### **Notice of Intent**

**Procedure Description:** OXY USA Inc kindly requests the to update the Deep Intermediate Cement Job to align with the agreed upon R111-P updates presented from the JITC. Updated cementing tables are attached.

### ALL PREVIOUS COAs STILL APPLY. CEMENT DESIGN UPDATE AS PER KPLA BEST PRACTICES (4-STRING INT1 X INT2 OPEN ANNULUS)

OXY USA INCORPORATED								
BATCH SUNDRY ID: 2	BATCH SUNDRY ID: 2706747							
TOP SPOT 12-13 FEDERAL COM	311H	3001547627						
TOP SPOT 12-13 FEDERAL COM	1H	3001548594						
TOP SPOT 12-13 FEDERAL COM	32H	3001548596						
TOP SPOT 12-13 FEDERAL COM	11H	3001548595						
TOP SPOT 12-13 FEDERAL COM	21H	3001547771						
TOP SPOT 12-13 FEDERAL COM	31H	3001548597

4-String Design – Open Int 1 x Int 2 Annulus

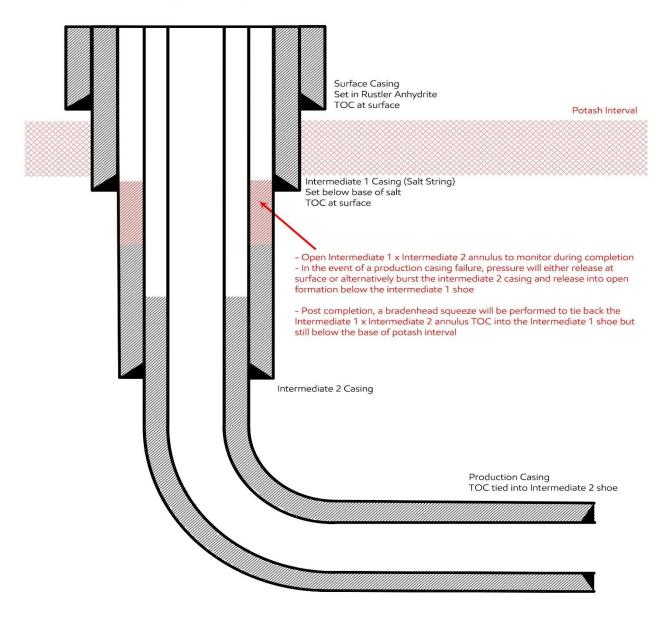
Oxy requests to update the Deep Intermediate Cement Job to align with the agreed upon R111-P updates presented from the JITC. I've included 4 tables below due to the different target benches:

Operator has proposed to pump down 7-5/8" X 9-5/8" annulus POST-FRAC. <u>Operator must top out cement after the bradenhead squeeze and verify cement to</u> <u>surface. Operator can also check TOC with Echo-meter. CBL must be run from TD</u> <u>of the 7-5/8" casing to surface if confidence is lacking on the quality of the</u> <u>bradenhead squeeze cement job. Submit results to BLM.</u>
